PROJECT: 3090 Zone North Interim Tank

TECHNICAL DRAINAGE STUDY SUPPLEMENT
(Response to CLV Comments)

3090 Zone North Interim Tank

Subject: Supplement to the Response to CLV Comments to the Technical Drainage Study for 3090 Zone North Interim Tank (DS-4854)

SECTION

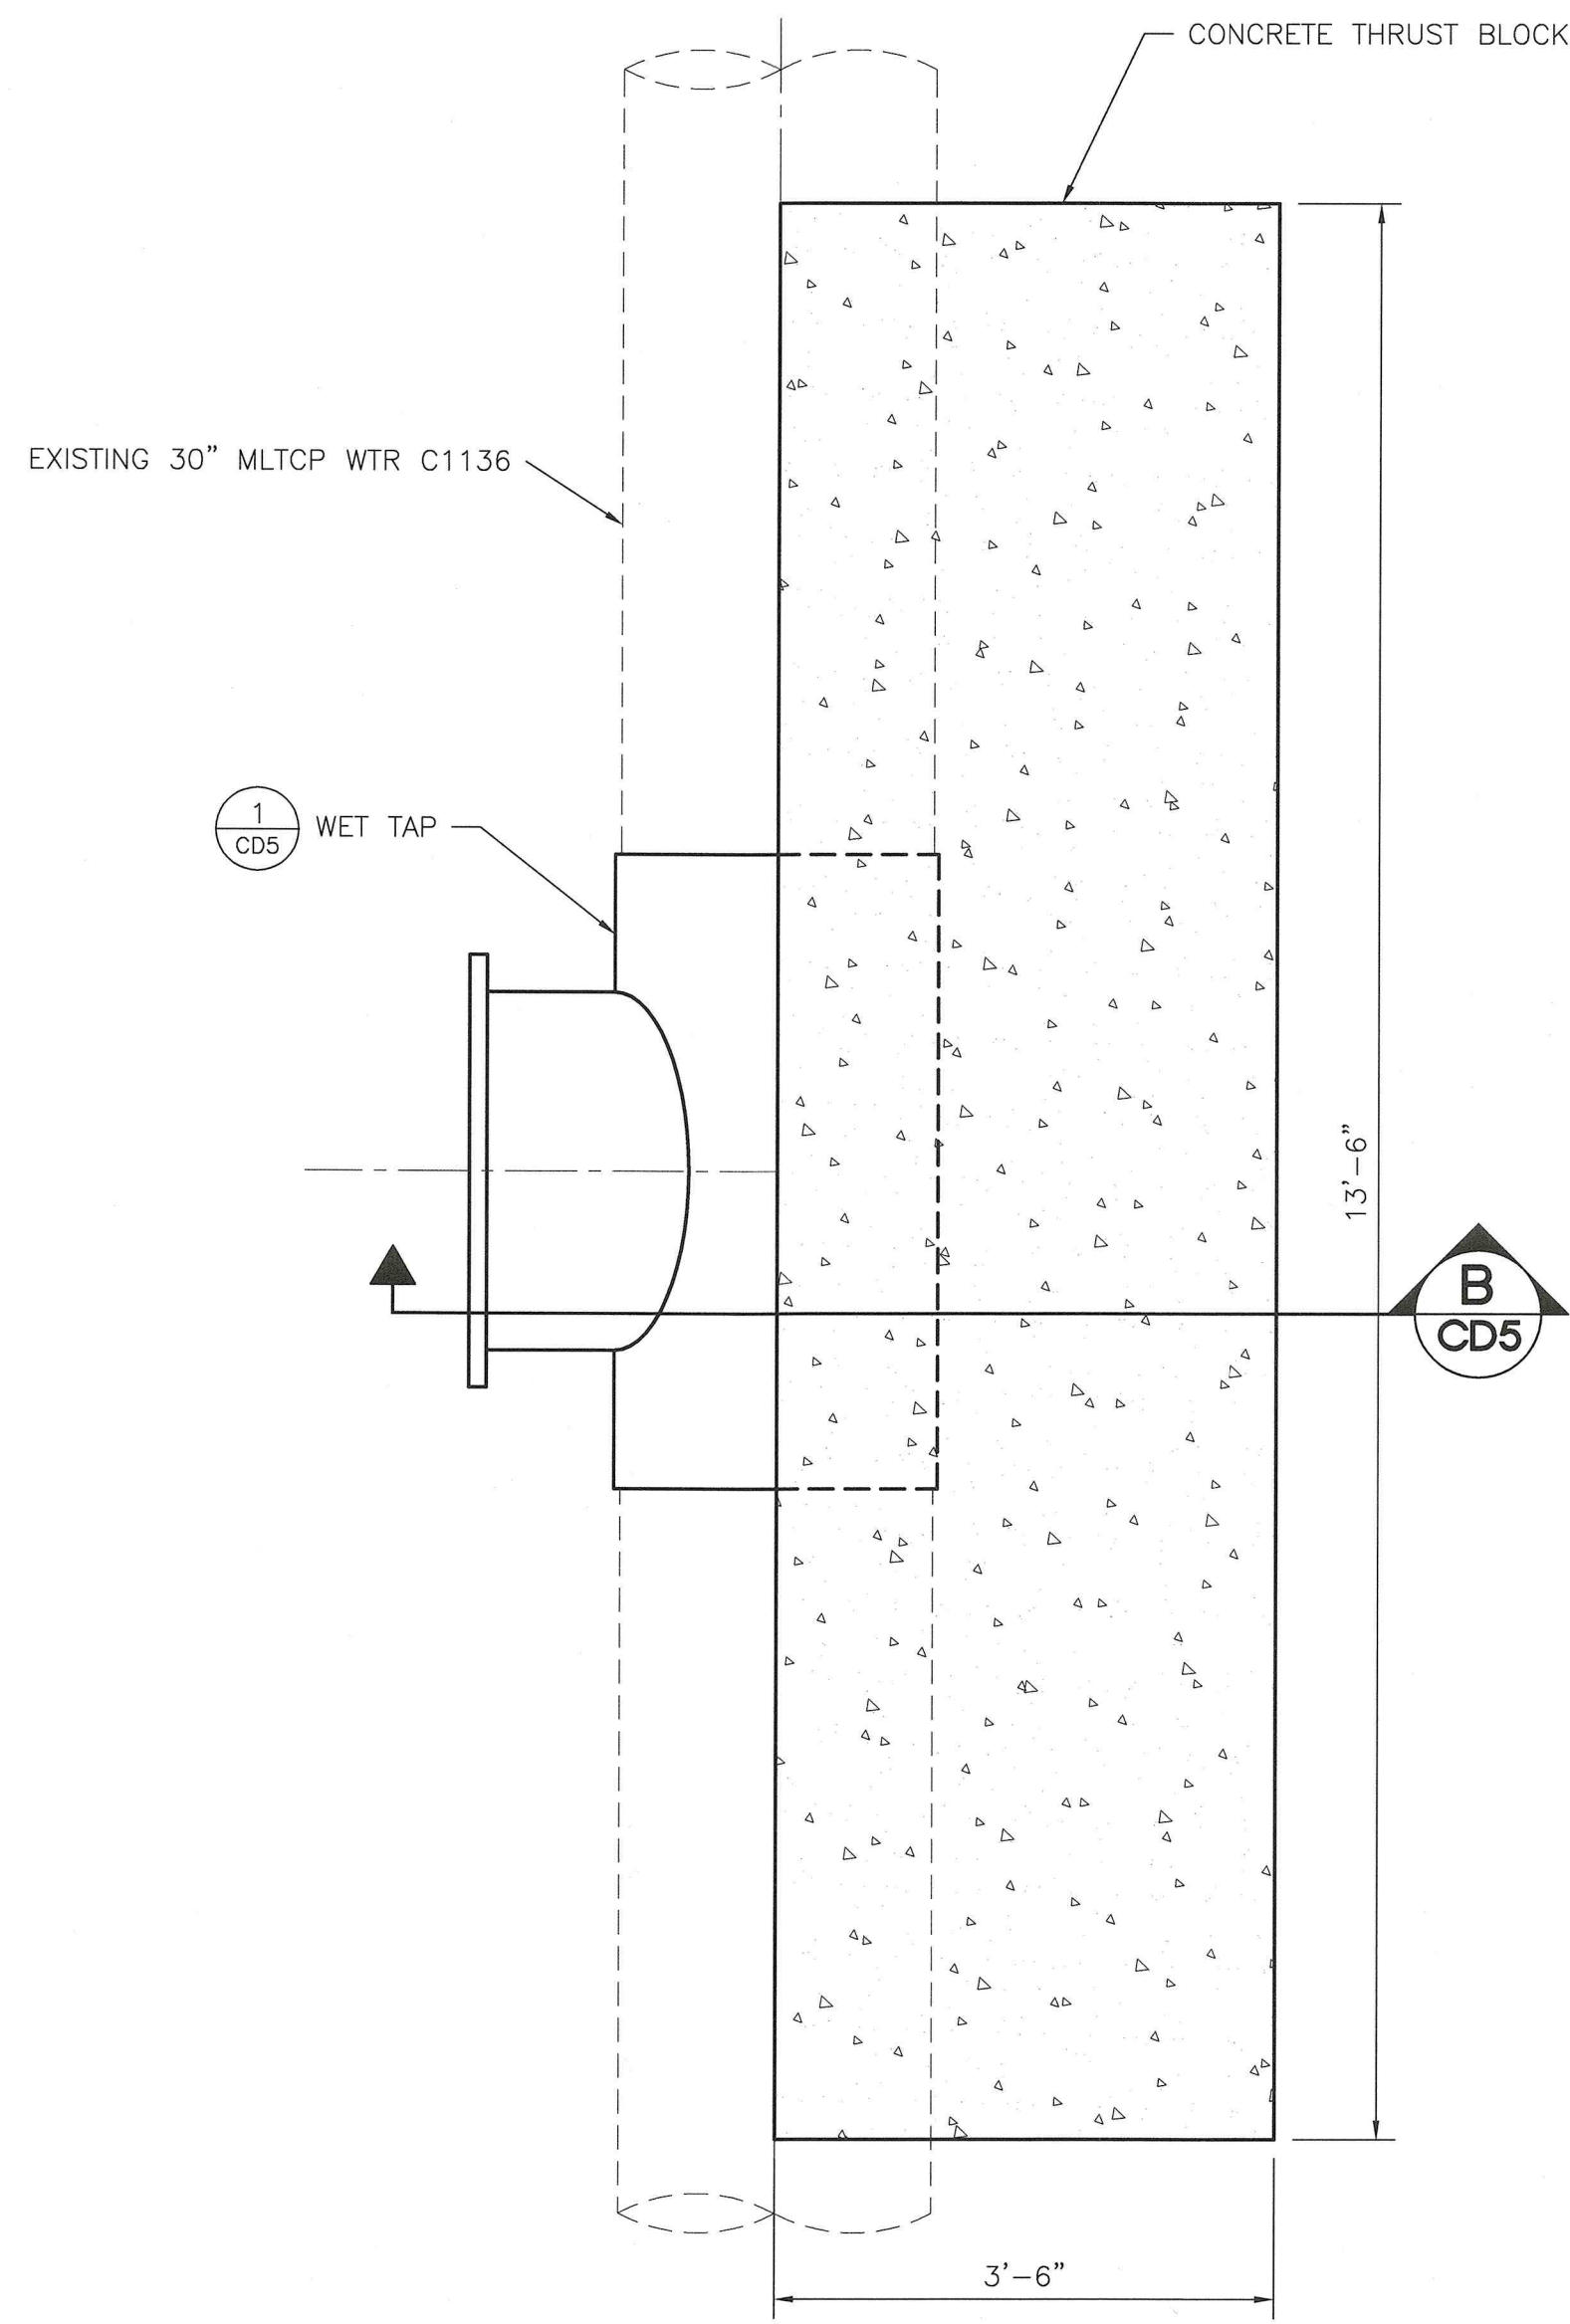
3. **Condition:** *In Section Detail A/CD5, provide a layer of geo-filter fabric beneath the proposed riprap over compacted base for erosion protection.*

- Provide riprap sizing calculation for the access roadside channel in *Centennial Parkway* to Flood Control Section prior to the final approval of the improvement plans.
- In *Section Detail A/CD5*, provide a layer of geo-filter fabric beneath the proposed riprap over compacted base for erosion protection.

Response: Section Detail A/CD5 has been revised with a layer of geo-filter fabric for erosion protection. The section detail has been provided with the revised plan, profile and detail sheets provided in Appendix D.
